Prairie Island Nuclear Generating Plant

**Supplement to License Amendment Request dated December 11, 2000
Conversion to Improved Technical Specifications (ITS)**

By letter dated December 19, 2001, the NRC Staff sent NMC requests for additional information (RAIs) regarding our LAR dated December 11, 2000 to convert to Improved Technical Specifications. Attachment 1 to this letter contains the NRC RAIs for ITS Specification 3.3.3, "Event Monitoring (EM) Instrumentation", Specification 3.3.4, "4 kV Safeguards Bus Voltage Instrumentation", and Specification 3.3.5, "Containment Ventilation Isolation Instrumentation", and the Nuclear Management Company (NMC) answers to these RAIs. With the responses attached to this letter and the responses previously submitted November 12, 2001 and January 25, 2002, all Section 3.3 RAIs have been answered.

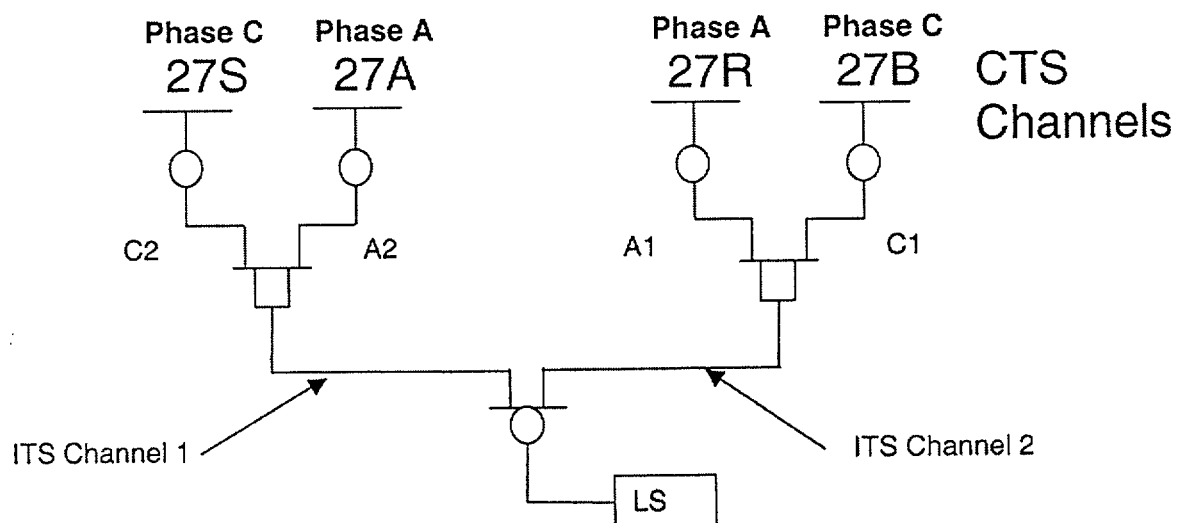
Provide a Discussion of Change for deleting CTS channels per phase and phases per bus requirements in Table 3.5-2B, Loss of Power Functions 8.a and 8.b.

CTS Table 3.5-2B, Function 8 requires 4 channels per bus, 2 per phase on 2 phases for both the Degraded Voltage (DV) sub-Function 8a and Undervoltage (UV) sub-Function 8b. ITS LCO 3.3.4 requires 2 channels per bus for both DV and UV Functions. As will be demonstrated in the following discussion, the redefinition of channels along with the associated Required Actions (RAs) either bound or are functionally equivalent to the CTS channels and their associated Actions. These changes make the Technical Specifications more technically correct and consistent with other safeguards logic channels. Unlike most other safeguards protection logic channels, the 4 kV DV and UV CTS channels are not designed to interact equally. For example, in the Reactor Trip System logic, when two out of four channels are required for actuation, any two channels can combine to initiate actuation. As discussed below, redefining the 4 kV protection channels in ITS make these channels more consistent with other logic schemes and more consistent with NUREG-1431.

Eight relays provide the inputs to the 4 kV DV and UV functions for each bus. Four relays per bus provide input to the DV function and four relays per bus provide input to the UV function. The sketch below is representative of the logic for both of these Functions on both buses. Two phases on each bus have two relays, labeled in the sketch as Phase A and Phase C. The input from the four relays, A1, A2, C1 and C2, shown on the sketch are the four channels per bus required by CTS. Input from A1 and A2 are the 2 channels for Phase A and input from C1 and C2 are the 2 channels for Phase C as required by CTS.

ITS has redefined the channels as shown on the sketch as ITS channels 1 and 2. The input from relays A1 and C1 combine in the AND-logic to provide ITS channel 1 input to the actuation circuitry. Likewise, input from relays A2 and C2 combine in the AND-logic to provide ITS channel 2 input to the actuation circuitry. These two channels satisfy the ITS requirement for two channels per bus. If one ITS channel is inoperable, LCO 3.3.4 RA A.1 requires placing the channel in bypass which means this channel will not provide input to the actuation circuitry. This is functionally equivalent to CTS Action 31 because when one CTS channel input to the AND-logic is bypassed, that AND-logic will not provide input to the actuation circuitry. If two ITS channels are inoperable, LCO 3.3.4 RAs B.1 through B.4 specify actions to be taken to place the plant in a safe condition equivalent to CTS Action 33.

inoperable and serves no purpose, that is, the CTS channel paired with the inoperable channel could be inoperable also with no further degradation of the protection logic. CTS Action 31 could also be entered for an inoperable CTS channel on the other bus which would mean that another two CTS channels are functionally inoperable. When a second CTS channel becomes inoperable the plant enters Action 32 which requires tripping the inoperable channel and verifying that no channels are inoperable on the other bus. As has been discussed above, if the second inoperable CTS channel is paired with the first inoperable channel, then the 4 kV protection logic has not in any way been further degraded.

If a second CTS channel is inoperable on the other channel pair, CTS Action 32 requires tripping the channel and verifying that no CTS channels on the other bus are inoperable. Prairie Island does not consider this to be a viable plant configuration since the CTS channels are not designed to be tripped. Therefore, for this condition, ITS requires taking actions equivalent to CTS Action 33 to assure the plant is operating safely assuming the load sequencer does not function. Therefore the requirements of ITS bound the CTS requirements and RA equivalent to Action 32 are not included in ITS.
